RE: **221 Princeton Drive**

TITLE: **HRPB Project Number 20-00100129:** Consideration of a Certificate of Appropriateness (COA) for partial window replacement for the property located at **221 Princeton Drive**; PCN#38-43-44-15-06-011-4250. The subject property is a noncontributing resource to the College Park Local Historic District and is located within the Single-Family (SF-R) Zoning District.

1950 Architectural Drawing, Front Facade

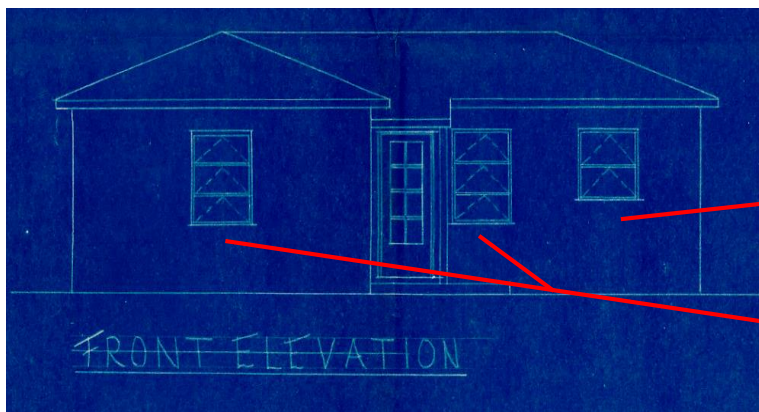
The proposed project, subject to the conditions of approval that require aluminum-framed windows that replicate the existing 2-light and 3-light awning windows, is consistent with Goal 1.4 of the Comprehensive Plan, which encourages preservation and rehabilitation of historic resources. Policy 3.4.2.1 insists that properties of special value for historic, architectural, cultural, or aesthetic reasons be restored and preserved through the enforcement of the City's Historic Preservation Ordinance to the extent feasible. Per the City's Historic Preservation Ordinance (LDR Sec. 23.5-4), the Lake Worth Beach Historic Preservation Design Guidelines, and the Secretary of Interior Standards for Rehabilitation, the replacement of missing features should be substantiated by documentary, physical, or pictorial evidence. The original architectural drawings and current photographs below provide evidence of the structure's original/existing window configuration on the front façade.

As is typical with awning windows on Masonry Vernacular structures, all lights are equally sized depending on the height of the window opening.

North Elevation (Fronting Princeton Drive)

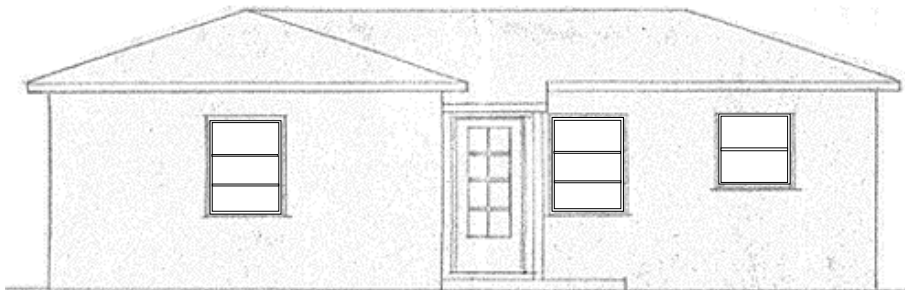
Proposed

Install three (3) new vinyl impact single-hung windows without divided-light patterns.

- Window Frame: Vinyl
- Window Frame Finish: White
- Muntin Type: None
- Glass Type: Clear or Clear Low-E

The Staff recommended partial window replacement for the front façade could be approved administratively at permitting. The partial window replacement, as proposed, could not be approved administratively as the window types, frame material, and lack of divided light patterns are a change in design from the original window configuration. The original/existing 3-light awning windows are being replaced with full-view single-hung windows with white frames. The original/existing 2-light awning window is also being replaced with a full-view single-hung window with white frames.

The Applicant is also proposing to install windows with vinyl frames. When replicating metal awning windows, Staff always recommends that the replacement windows utilize aluminum window frames as they are the most historically compatible frame options for material, design, color options, and overall proportion. In addition, aluminum-framed windows are commonly utilized due to their wide availability, versatility, and affordability.

The window replacement, as proposed, utilizes single-hung windows on all of the front façade's openings. Based on the Design Guidelines, an Applicant may propose an architecturally compatible alternative for window replacement. The Masonry Vernacular architectural style section of the Design Guidelines, included as **Attachment E**, provides examples of common window types. Staff contends that the proposal is *unsuccessful* in replicating the original windows. Per the Design Guidelines (pg.61), hung windows are only appropriate on Masonry Vernacular structures constructed before 1930. Post 1930, Masonry Vernacular windows consisted of "either steel casements, or aluminum awning, jalousie, or fixed pane windows". Architecturally compatible alternatives are appropriate when none of the original windows remain and there is no architectural or photographic evidence of their design. The structure's original windows remain and can be readily replicated with modern window products. Additionally, it is not possible to add exterior muntins to the proposed windows to arrive at a similar divided light configuration where the lights are equally sized for both window sizes.

Staff Recommendation (Most Successful Replacement)

Install two (2) aluminum impact casement windows (Alternates: fixed, awning, or hopper) with divided-light patterns to replicate the 3-light awning windows. Install one (1) aluminum impact full-view single-hung window (Alternates: casement, fixed, awning, or hopper with divided-light patterns) to replicate the 2-light awning windows).

- Window Frame: Aluminum
- Window Frame Finish: Clear-Anodized
- Muntin Type: Exterior Raised Triangular
- Glass Type: Clear or Clear Low-E
